United States Nuclear Regulatory Commission Official Hearing Exhibit		
In the Matter of: POWERTECH USA, INC. (Dewey-Burdock In Situ Uranium Recovery Facility)		
	ASLBP #:	10-898-02-MLA-BD01
	Docket #:	04009075
	Exhibit #:	APP-016-D-00-BD01
	Admitted:	8/19/2014
	Rejected:	
	Other:	
	Identified:	8/19/2014
	Withdrawn:	
	Stricken:

### **Background Radiological Characteristics**

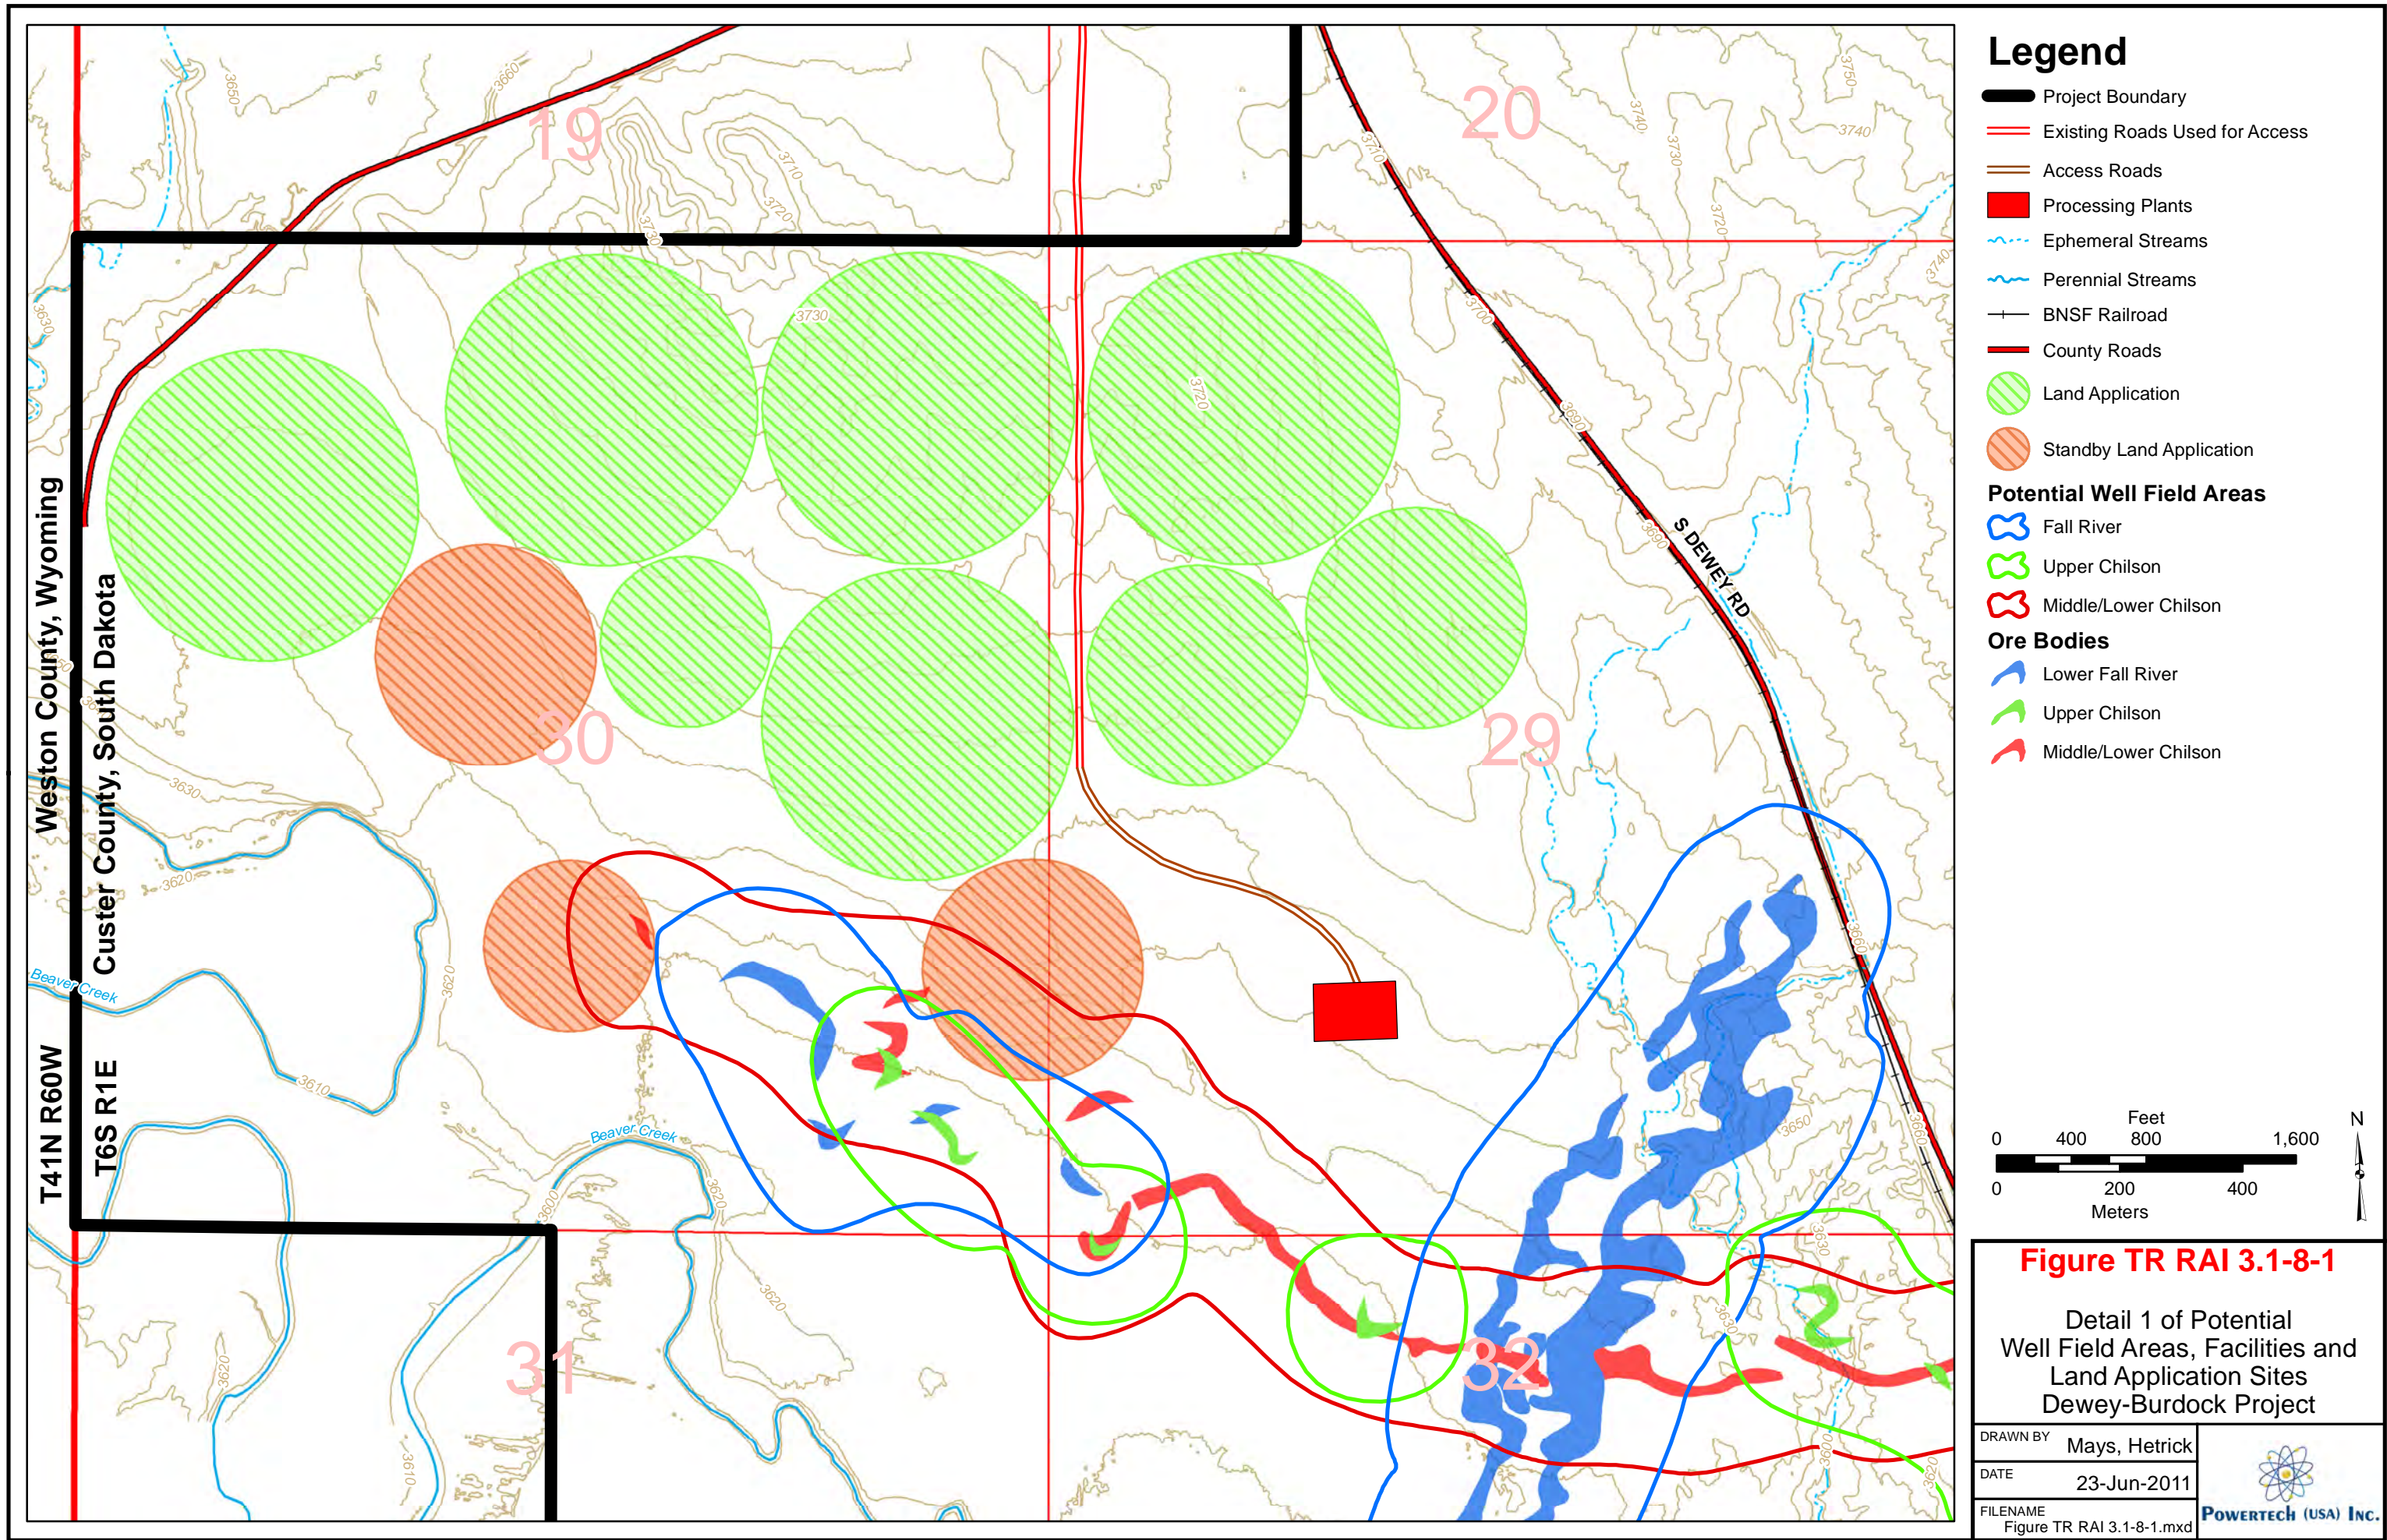
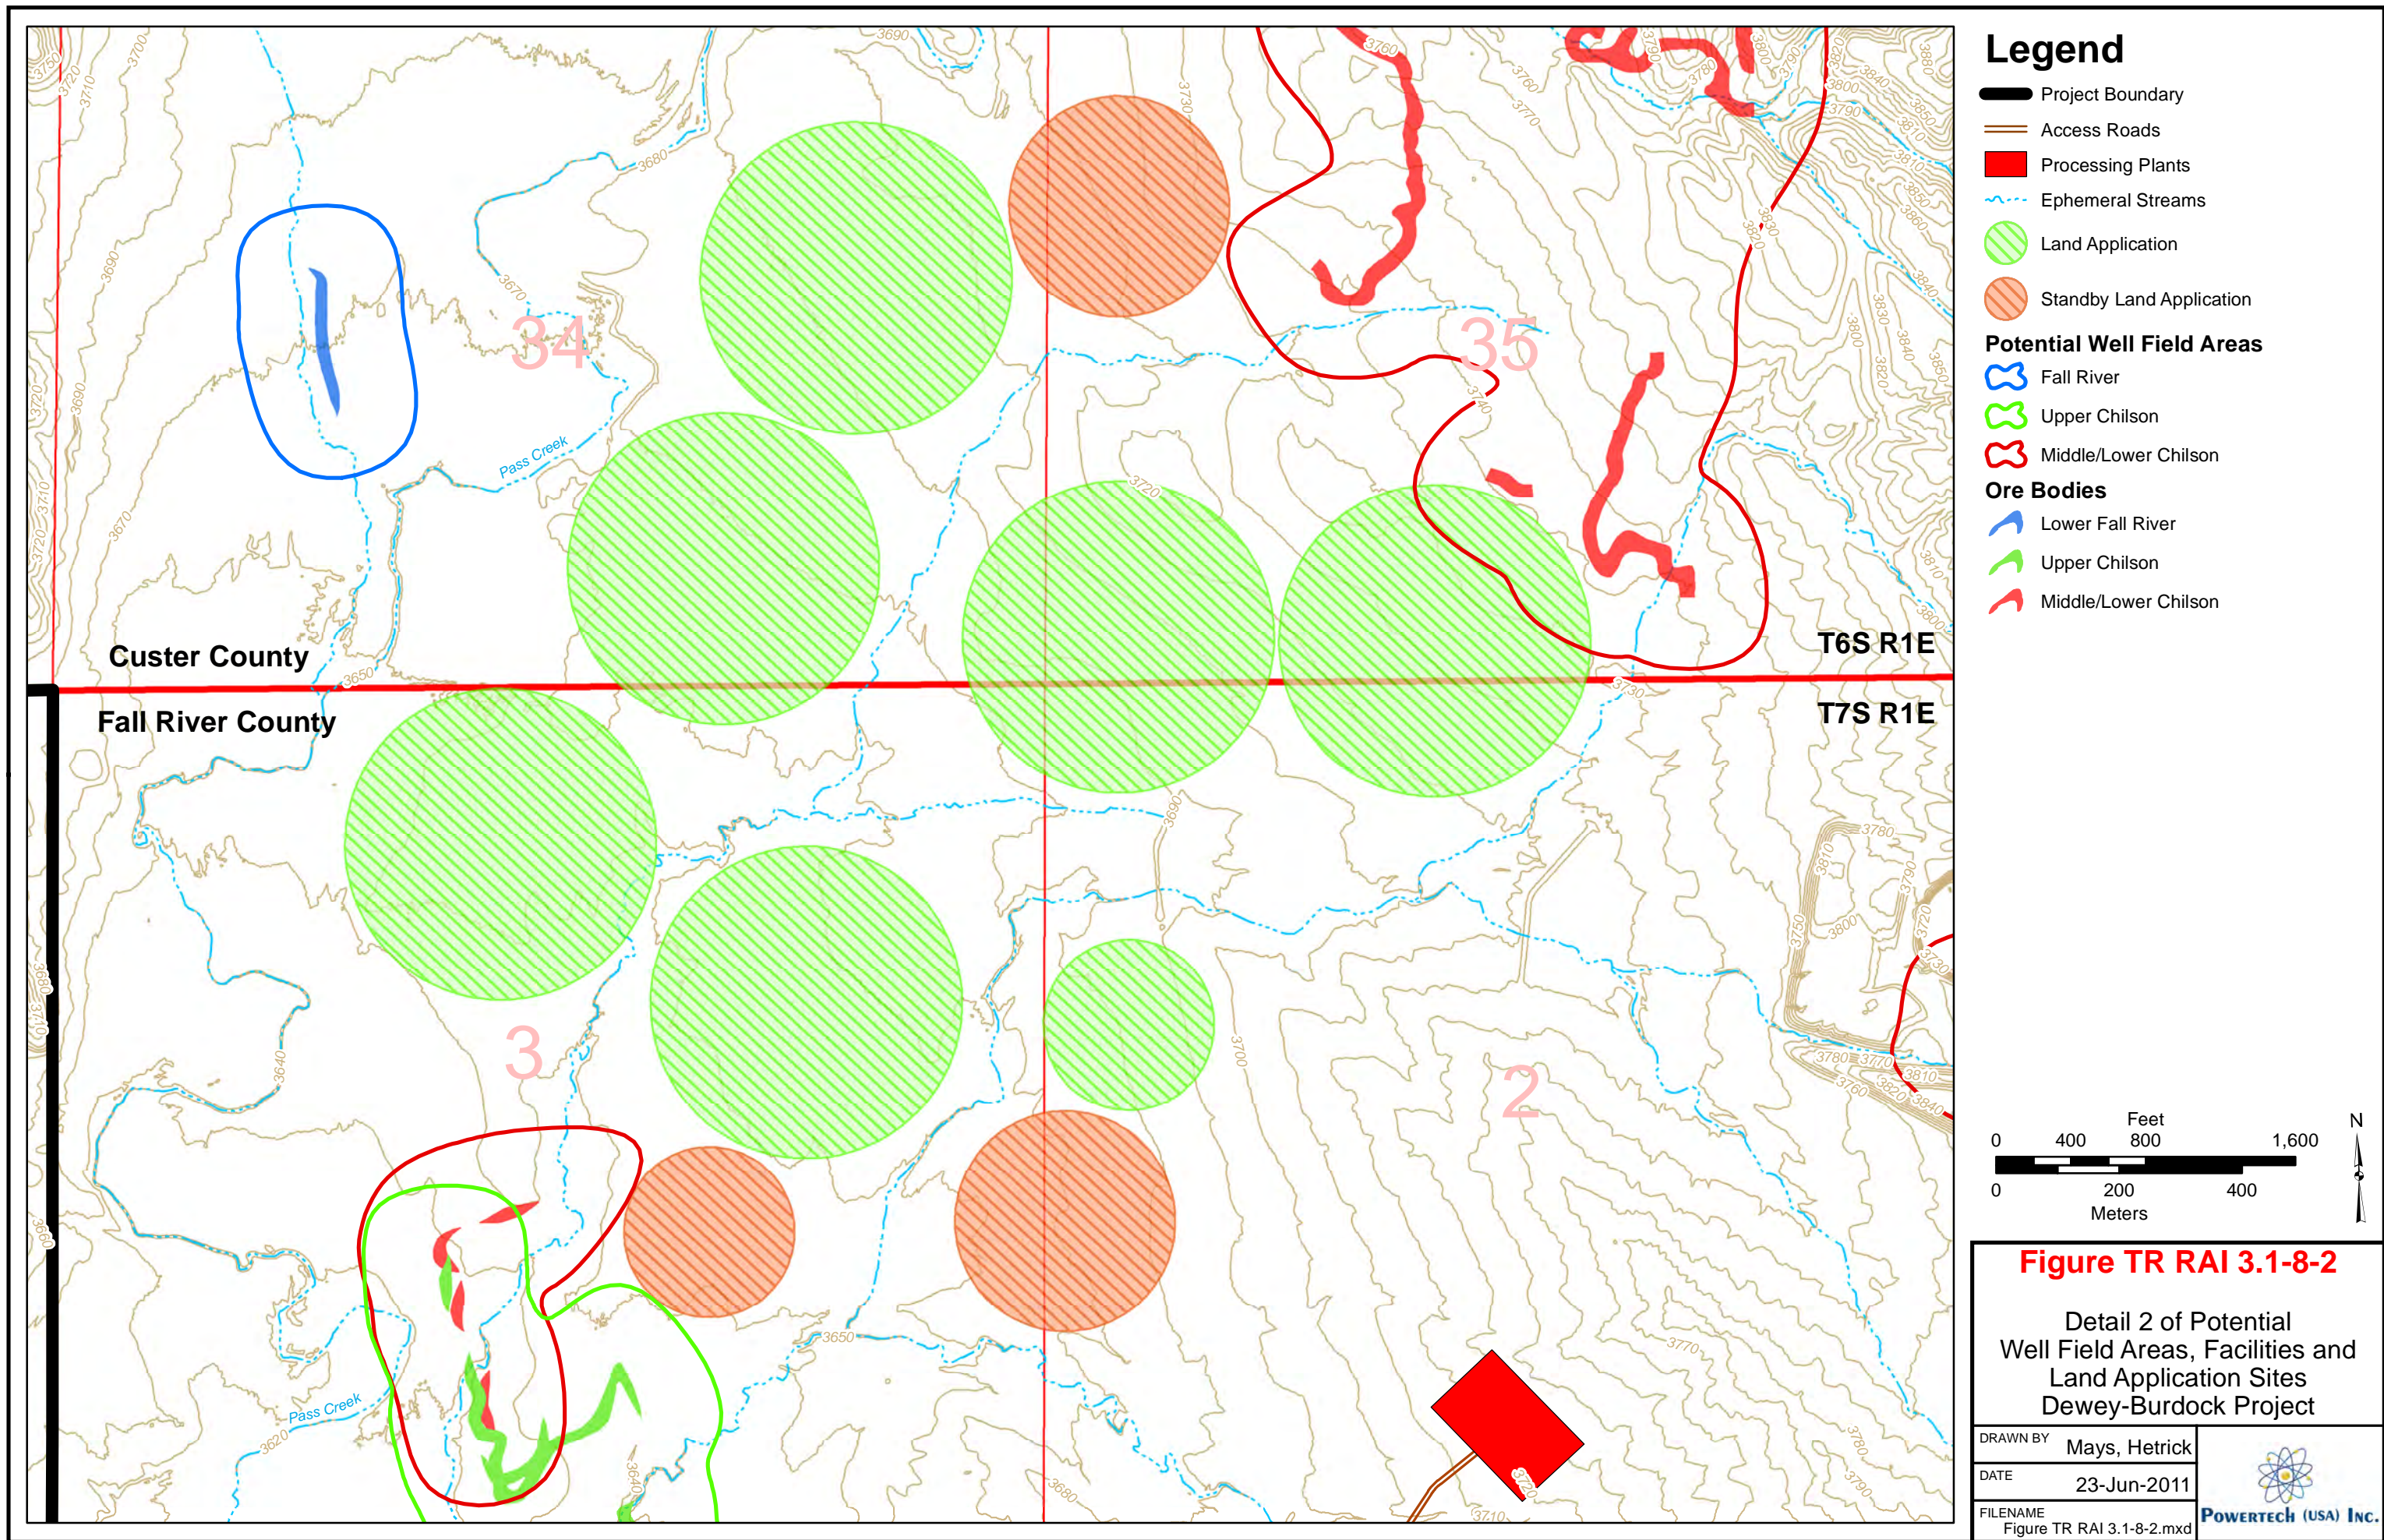
***On Supplemental Exhibit 3.1-4, various land application areas overlap outlines of two future mine units. Please confirm the location of the land application areas. If the land application areas overlap proposed well fields, please provide further information regarding the manner in which both the well field and land application areas will be operated.***

Figure TR RAI 3.1-8-2 shows that there is also limited potential overlap between Burdock land application areas and potential well field areas. In this case overlap will likely be limited to perimeter monitor wells.

Although overlap between active land application areas and potential well field areas will be limited, there may be times that production, injection and monitor wells are operated within active land application areas. Powertech will design and construct the well fields and land application systems to avoid any potential conflicts and minimize potential risks. The irrigation nozzles will be suspended above the well head covers, and wells and fences will be positioned to avoid the center pivot wheel pathways. Injection, production and monitor wells will have sealed well heads to prevent entry of the land application water. The well heads will also have sufficient aboveground casing to ensure that surface water cannot enter the wells. Injection and production pipelines will be buried and will not conflict with land application systems. Perimeter monitor wells will have pressure transducers that will allow remote monitoring of water levels. If necessary, discharge piping and pressure transducer cable will be installed from the monitor wells to remote sampling locations outside of the land application area. This would allow Powertech personnel to measure water levels and sample monitor wells without traveling through active land application areas. Inspections of well field components will be conducted routinely as discussed in the response to TR RAI 3.1-1.

**Figure 5.7-6**

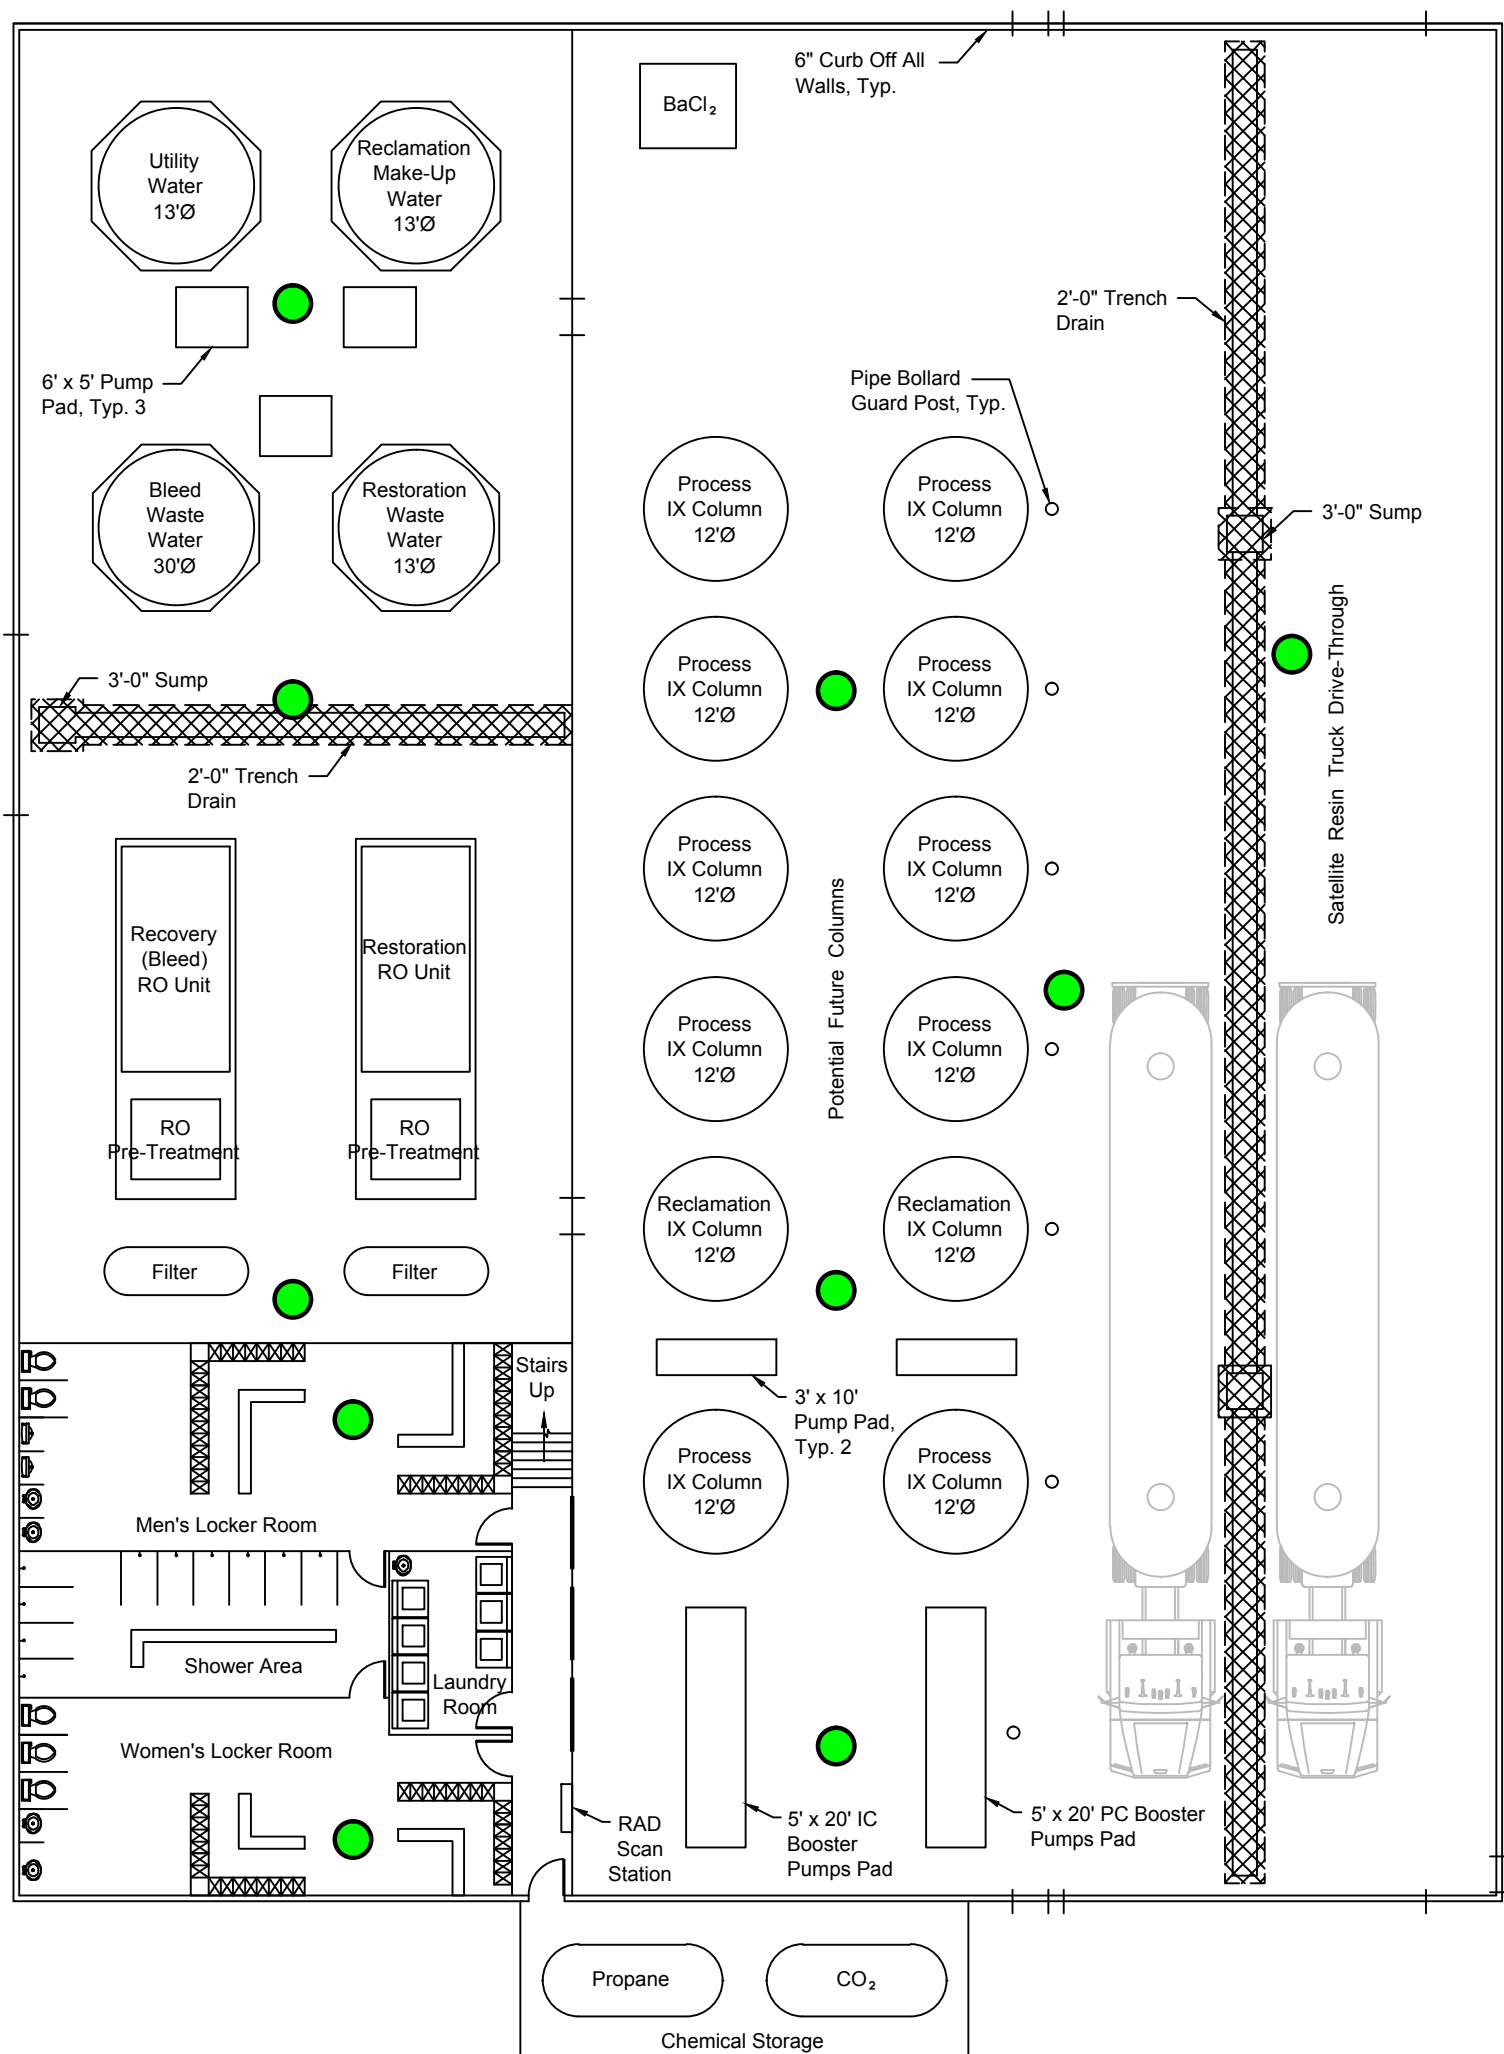
*In Section 5.7.3.1 of the TR, the applicant described proposed radon monitoring locations based upon expected radon decay product concentrations. Figures 5.7-6 to 5.7-9 show these locations at the satellite and central processing facilities. However, it is not clear if/how the applicant will evaluate if these proposed locations remain appropriate once operations have started and throughout the operational lifetime of the facilities. Regulatory guides 3.46, 8.25, and 8.30 provide recommendations regarding the location of air samplers. Please address the following in regards to radon decay product monitoring:*

Section 5.7.3 of the revised TR will include the following discussion.

According to Regulatory Guide 8.30, measurements of radon decay products are a better measure for worker dose than measurements of radon. Therefore, measurements of radon decay products will be made in the facility.
